Planning Reference – 218/0910/P

Re: The Proposed Redevelopment of 20-23 Greville Street, London EC1N 8SS

With reference to representations made by Mr Wilson in relation to the above planning application, we have reviewed the issues raised by Mr Wilson's appointed consultant, Delva Patman Redler (DPR) in their letter dated 14 August 2018.

Image 1 – 7 Bleeding Heart Yard First Floor Plan

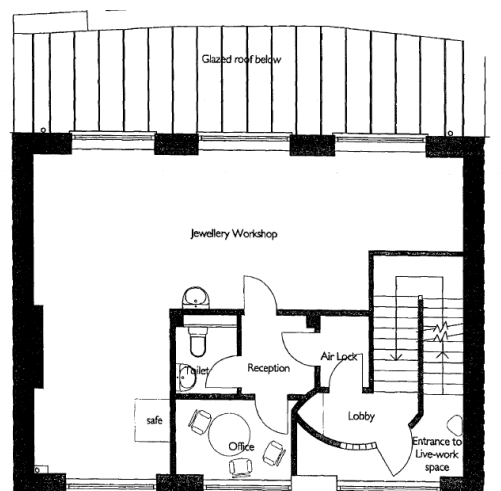
- 1.4. We have obtained a floor plan for the first floor of 7 Bleeding Heart Yard from the London Borough of Camden’s online planning database. This shows the first floor to be in use as a jewellery workshop and office, rather than the Bistro stated in DPR’s letter. We have provided this plan in Image 1 below (windows on the south side of the plan are those facing onto Bleeding Heart Yard).

- 1.5. The plan shows one of the three windows at first floor facing the application site serves a dual-aspect jewellery workshop. Another window serves a small office and the remaining window serves a lobby.

- 1.6. Whilst it is debatable whether a jeweller's workshop would be considered as having 'a reasonable expectation' of daylight and sunlight amenity for operational purposes, we have prepared additional analysis for this space for completeness. We have undertaken Vertical Sky Component (VSC) and Annual Probable Sunlight Hours (APSH) assessment for this window and, for the avoidance of doubt, the adjacent office window.

- 1.7. As shown in Table 1 below, the office window (W5) remains above 0.8 times the existing value, in accordance with BRE daylight recommendations. The workshop window facing the application site (W6) would retain a VSC value 0.77 times the existing value, narrowly below the BRE baseline of 0.8 times. The effect on the other three windows serving this room would be negligible, and all three would remain well within the BRE guidelines.
